THE ROYDON ROUND-UP

Issue 21: Nov 2025

Roydon delivers response to pylon plan

The pylon route in purple around Roydon, including the section between Wortham Ling and Roydon Fen.

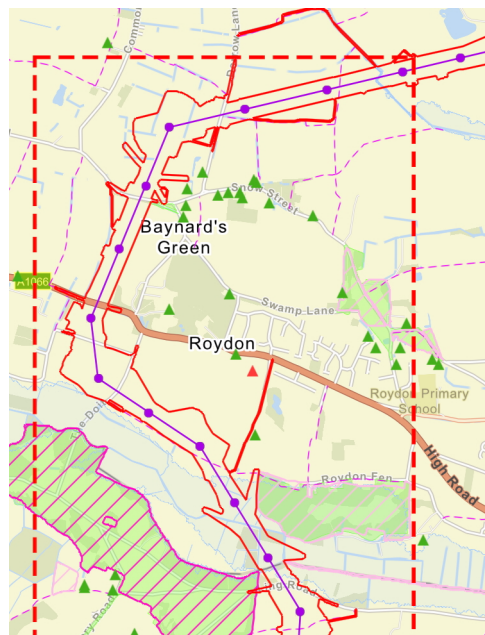
The **Waveney Valley valued landscape** will suffer great harm from pylons. The route would take them through the narrow gap between the rare habitats of Roydon Fen and Wortham Ling, a Site of Special Scientific Interest. The setting of both would be damaged forever. The fact that undergrounding is happening in Dedham Vale is proof that the Grid understands the damage pylons cause. It may be an Area of Outstanding Natural Beauty, but to many residents the Waveney Valley is just as important a landscape.

The route through the narrow gap between Roydon and Bressingham requires a number of sharp turns in **contravention of Holford Rule 3**. This seeks to ensure the very minimal use of larger angle towers which, in the flat landscape around Roydon, will be even more visually damaging.
